CC&V - Proposed Water Pond drawing

Attached is drawing of temporary fresh water holding pond we would like to construct and utilize for filling water trucks at CC&V for dust mitigation efforts, particularly as soon as we can because of the draught conditions in the area. The location is on the Squaw Gulch Overburden Storage Area within the current disturbance footprint. The liner and area would be reclaimed as part of the approved plan for the SGOSA. You can see where the water line will come from the line installed as part of the Mill water line.

CC&V - VLF2 PROJECT
PROPOSED WATER HOLDING POND
CC&V - CRIPPLE CREEK, CO

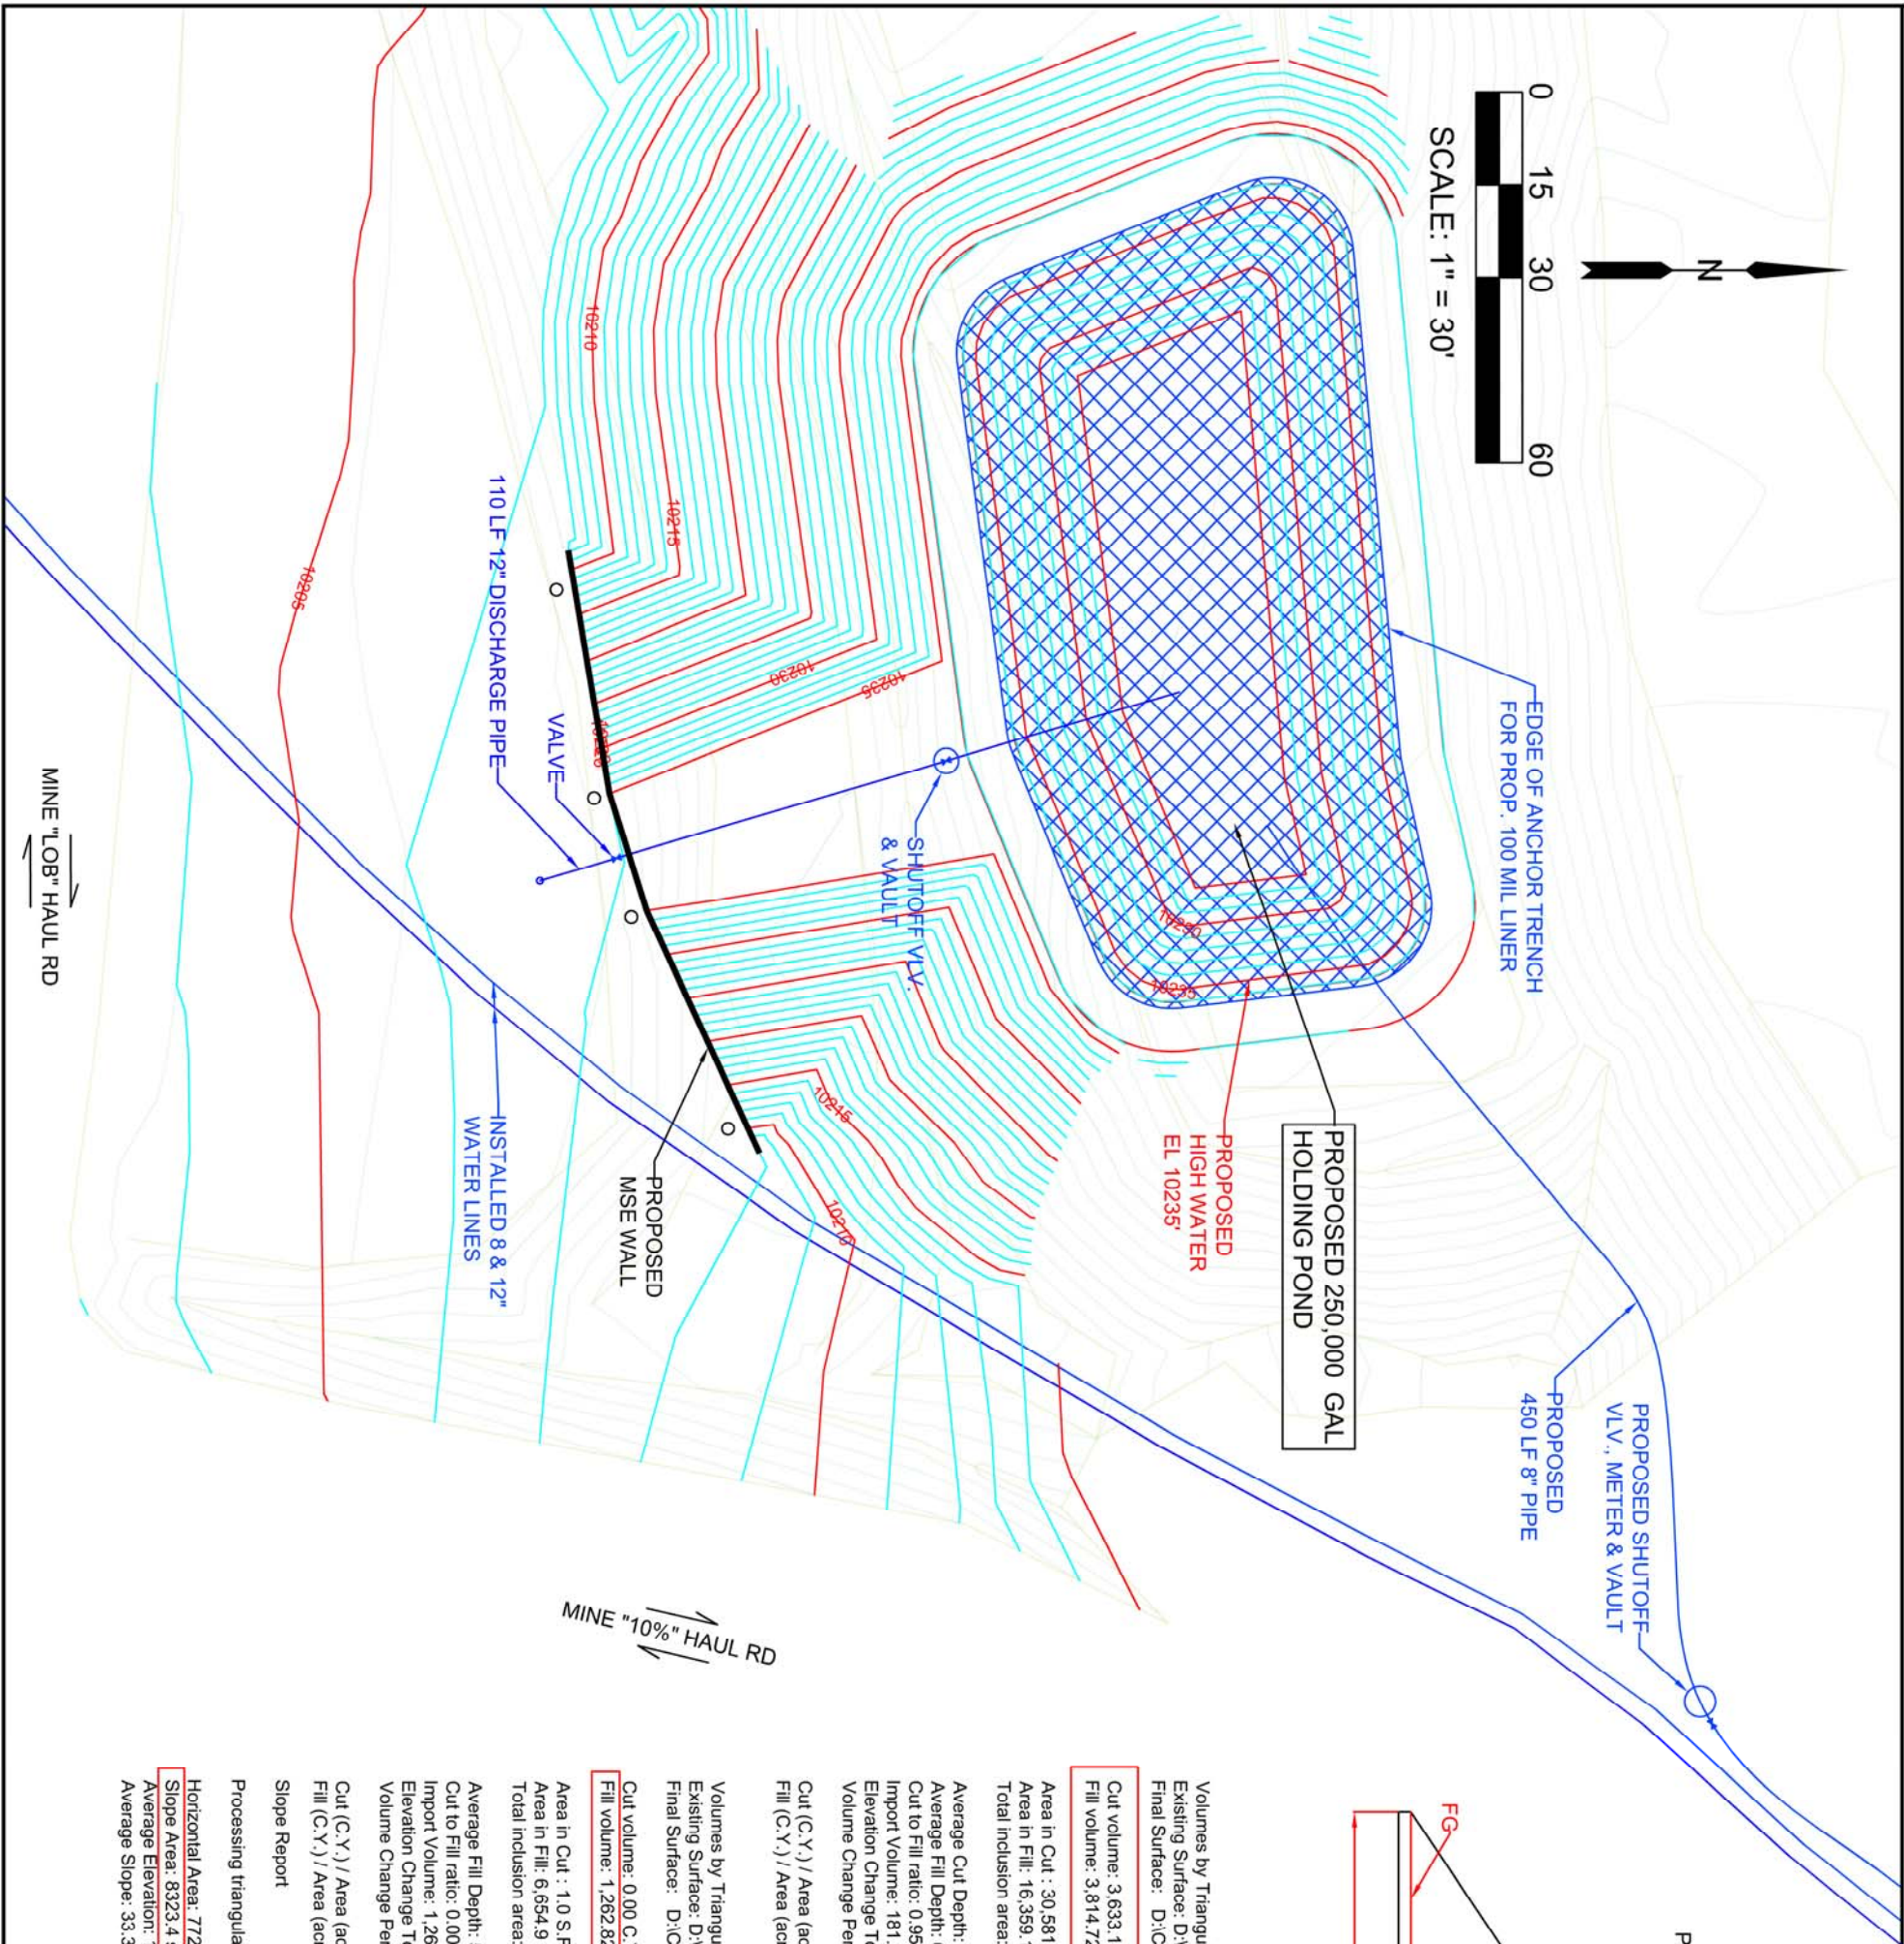
The DRMS understands that this proposed pond is intended to be a temporary facility to support construction activities (e.g., dust control) related to the Squaw Gulch Valley Leach Facility (SGVLF). Furthermore, it is understood that the pond will be decommissioned upon the completion of SGVLF construction anticipated to be in 2016.

Should plans change, please notify the DRMS within 30 days of a change to the life of the pond or its intended use.
